QUESTION 110.1

SSES-FSAR

**SUSQUEHANNA STEAM ELECTRIC STATION
UNITS 1 AND 2
FINAL SAFETY ANALYSIS REPORT**

FSAR REV. 46, 06/93

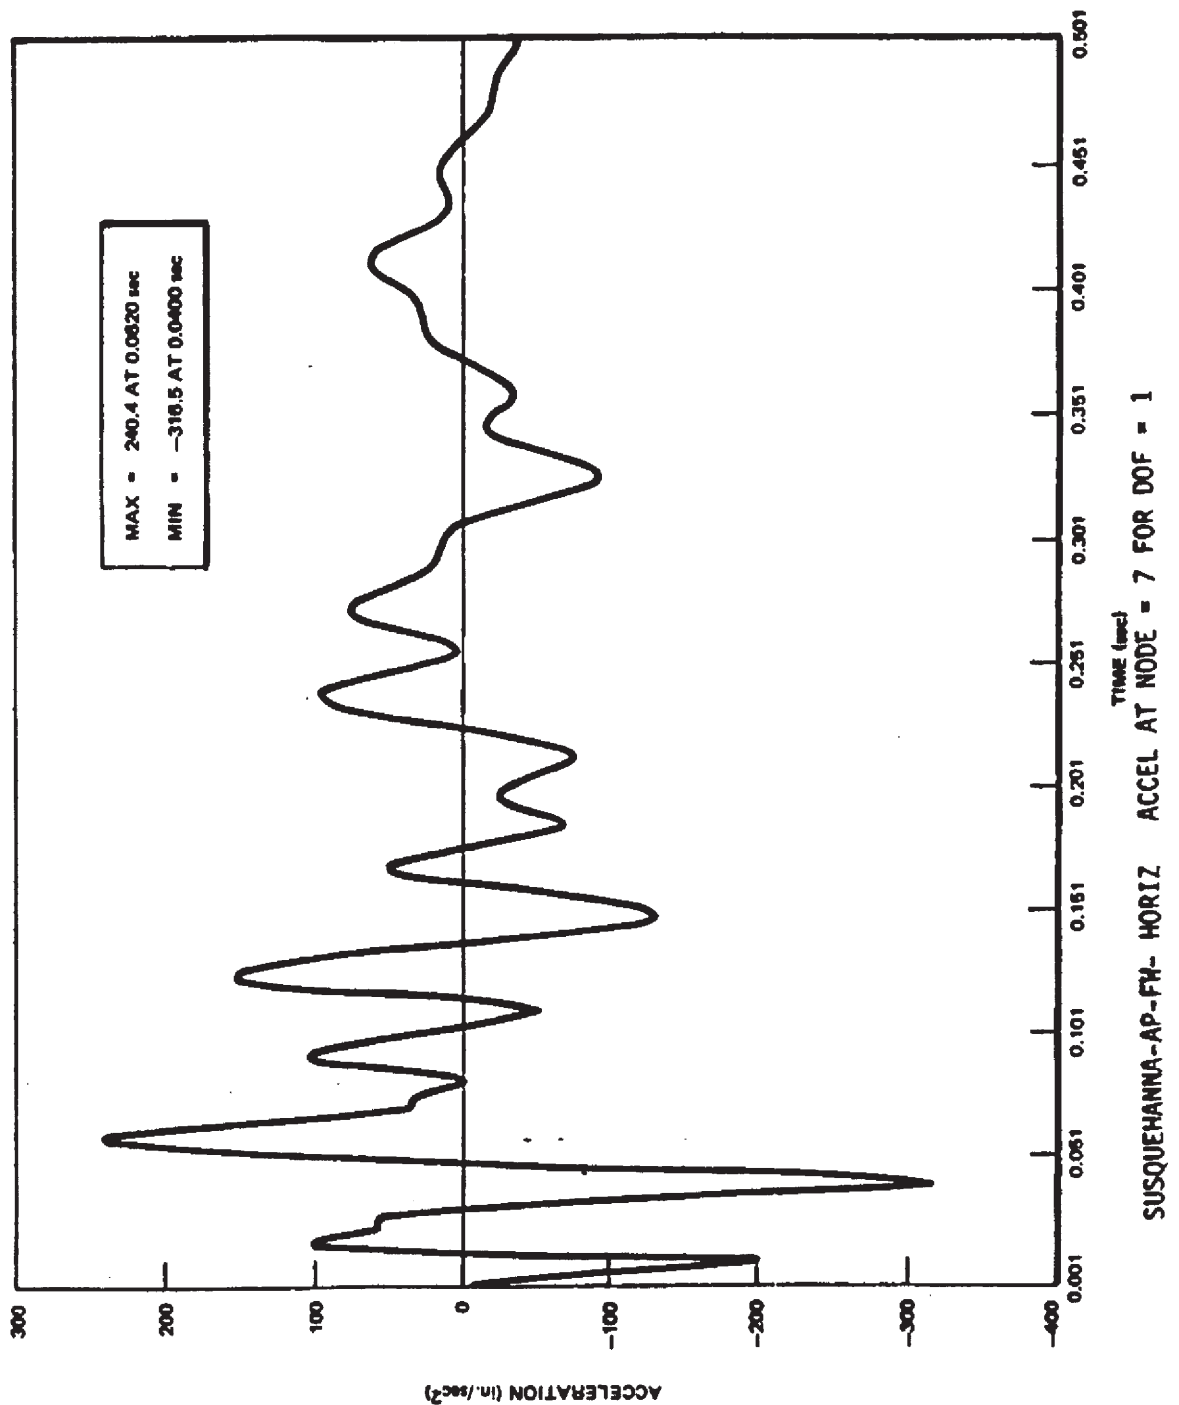
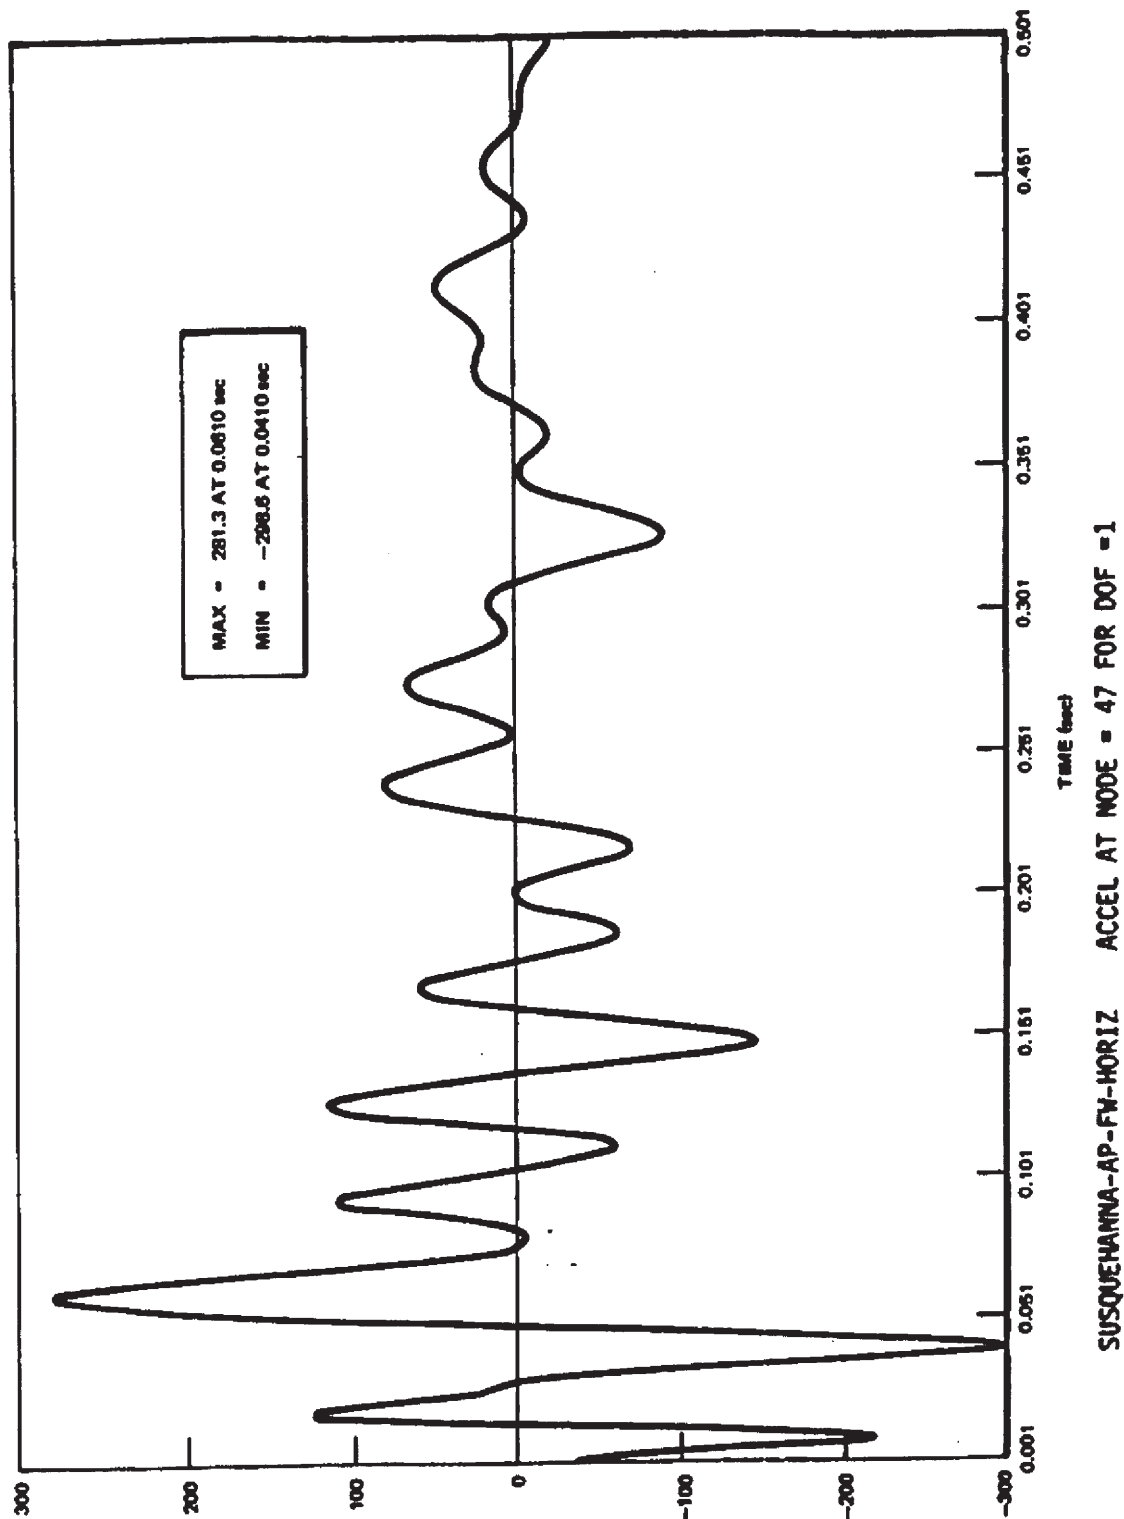
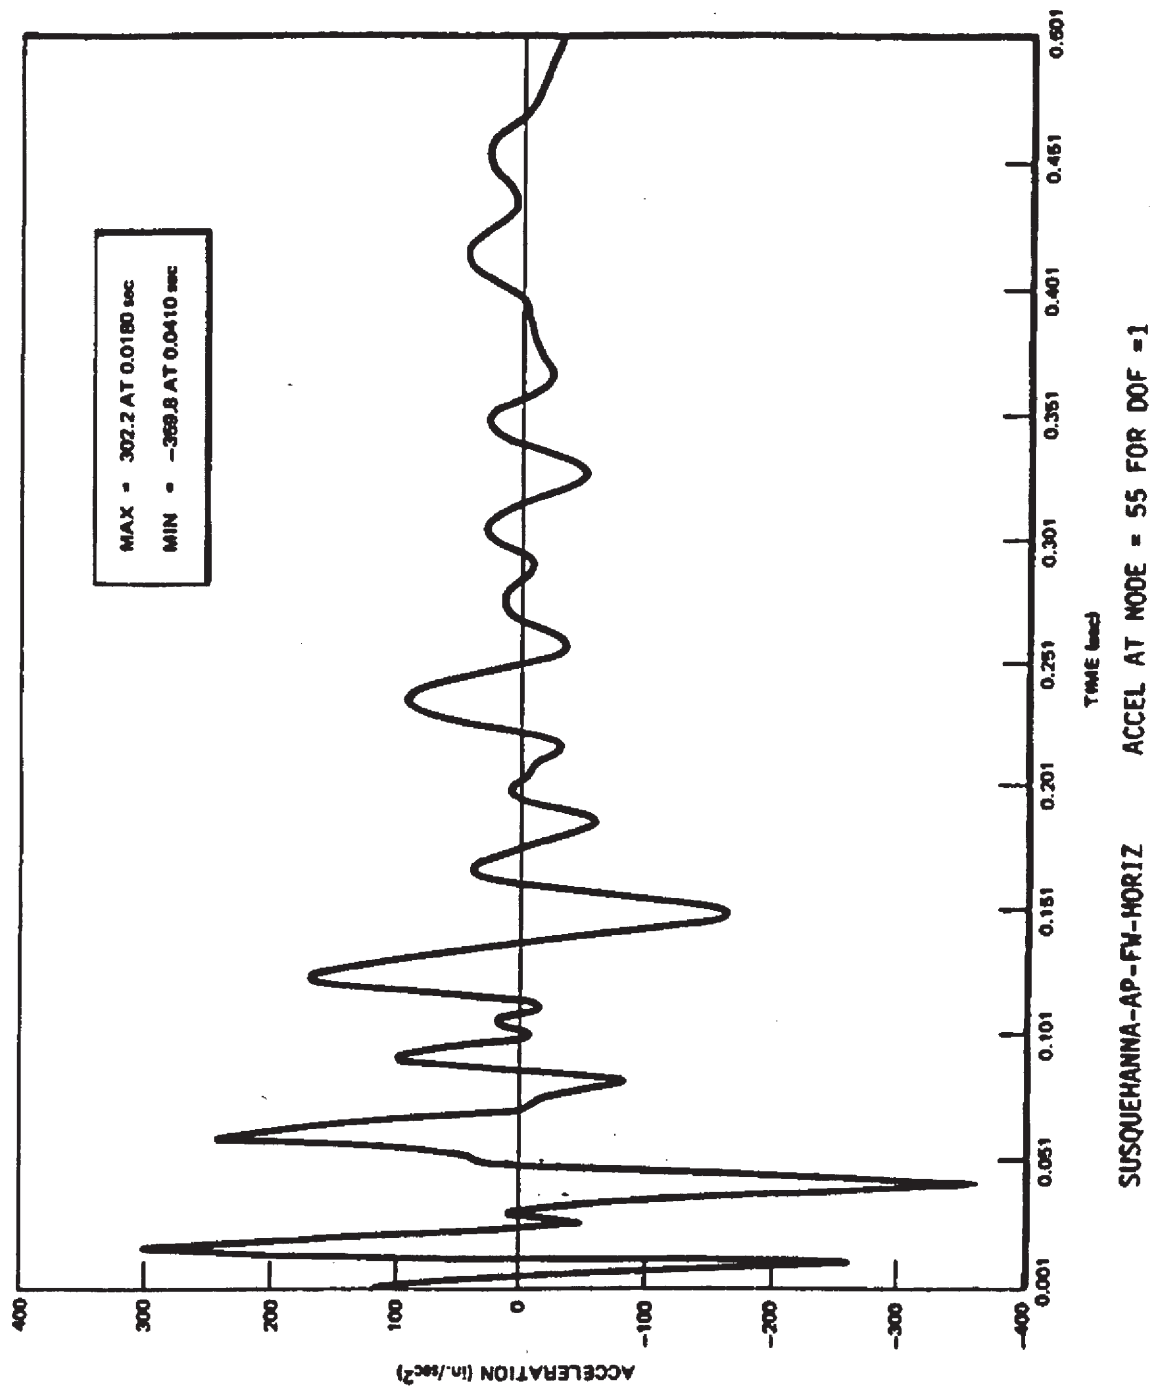
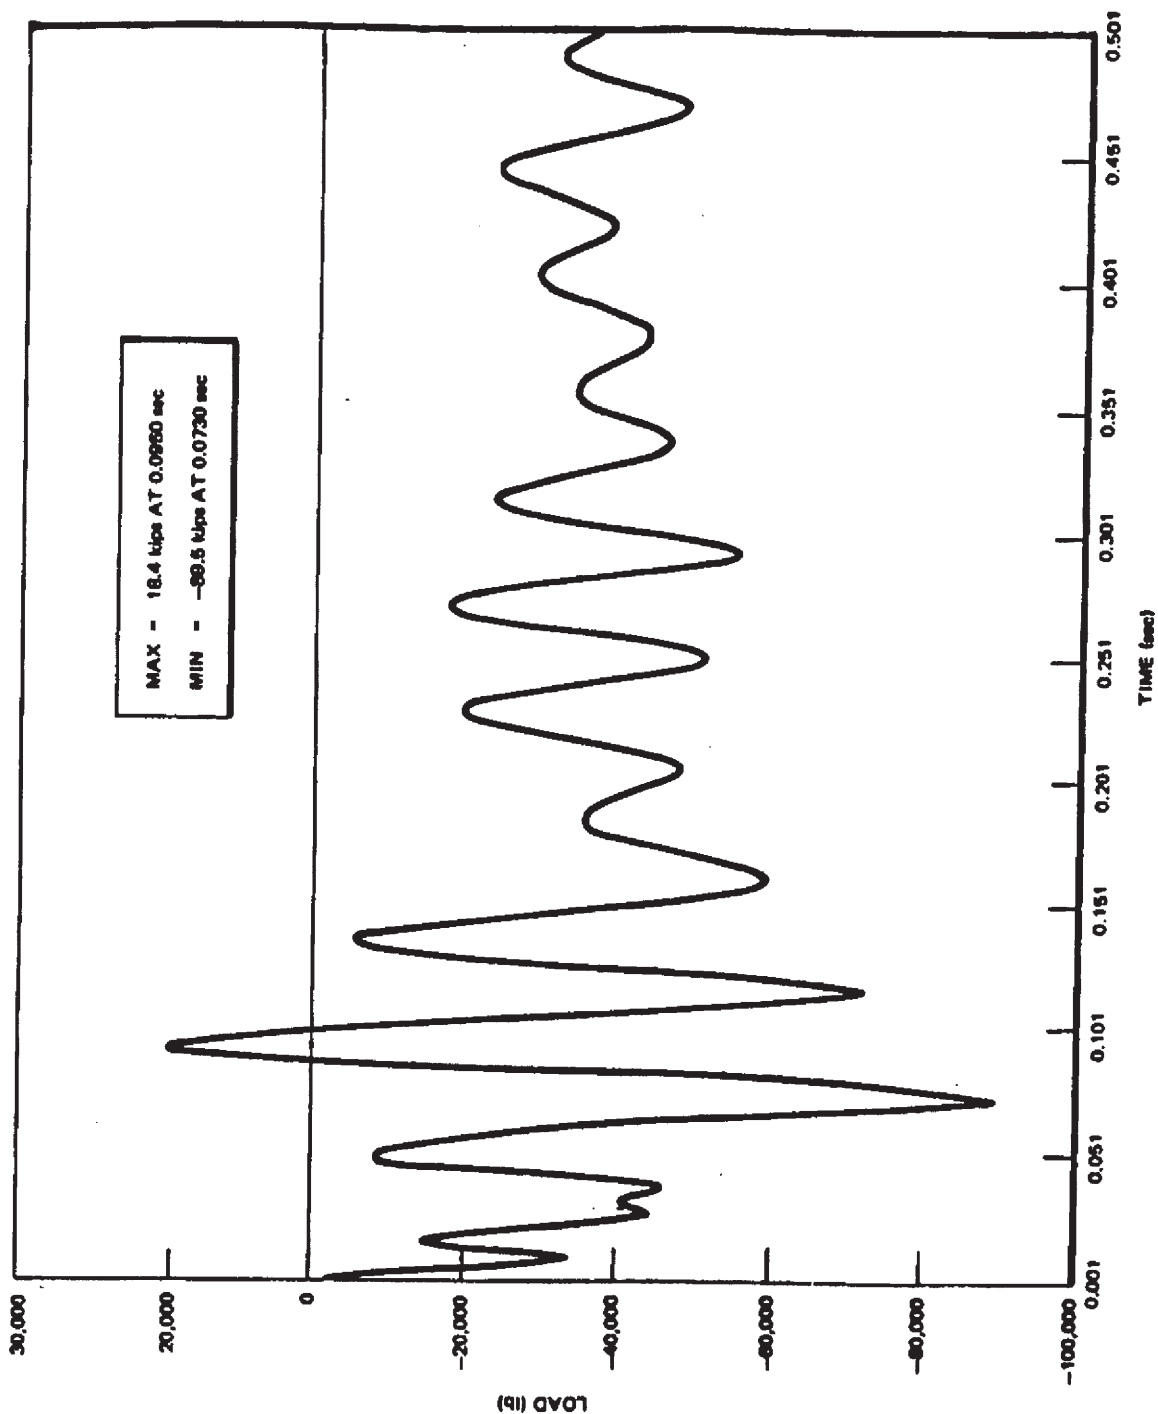
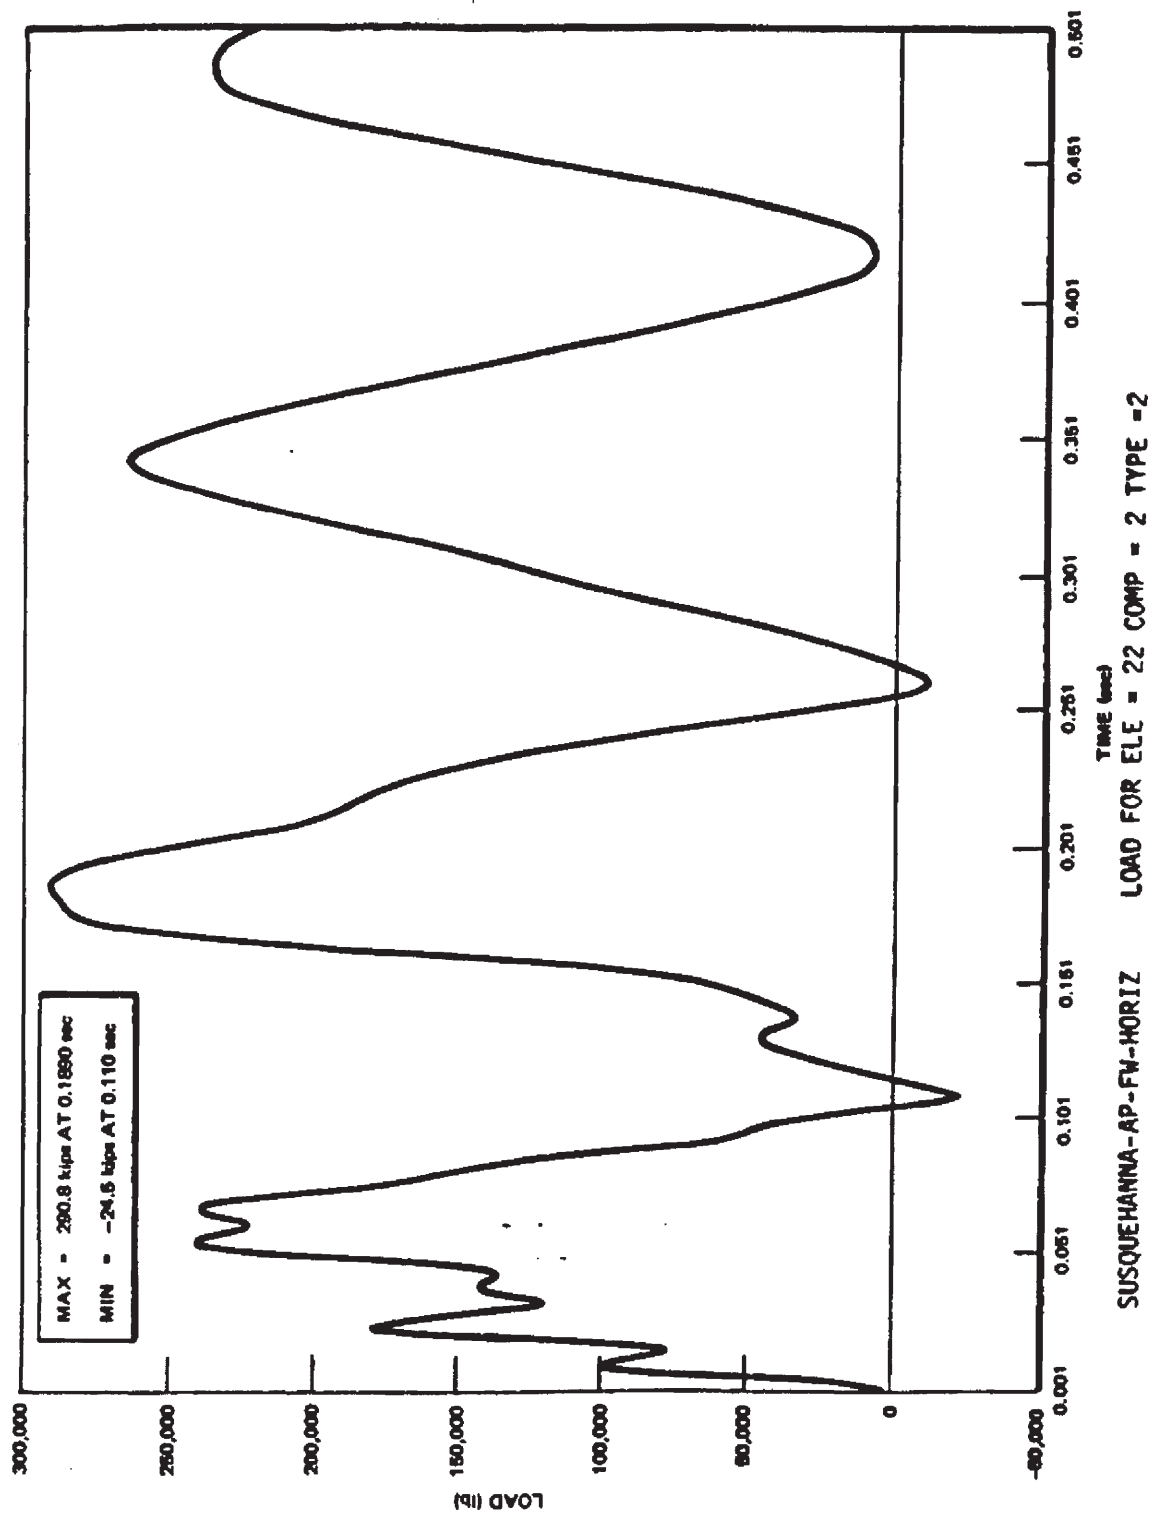
- a) Provide response time histories at one key location (having either the maximum stress combination or the most critical deflection combination, whichever is governing the design) for each of the following internal components:
 - (1) Jet pump
 - (2) Shroud wall
 - (3) Shroud head
 - (4) Control rod
 - (5) Instrumentation guide tube
 - (6) Core plate

For each location, separate response time histories for the various load effects associated with the SSE and most severe pipe break event should be provided.

- a) The following additional response time information for selected internal components under the SSE and the most severe pipe break accidents is provided.

Figures 110.41-3 thru 110.41-10 - Response time history plots due to horizontal SSE.

Figures 110.41-11 thru 110.11-16 - Response time history plots due to vertical SSE.

Figures 110.41-17 thru 110.41-24 - Response time history plots due to recirculation pipe break.

Figures 110.41-25 thru 110.41-32 - Response time history plots due to feedwater pipe break.

As for the pipe break events, we have considered both the feedwater line break and the recirculation line break. Judging from the response time histories, it is not conclusive as to which one is governing. Hence, we have included both sets.
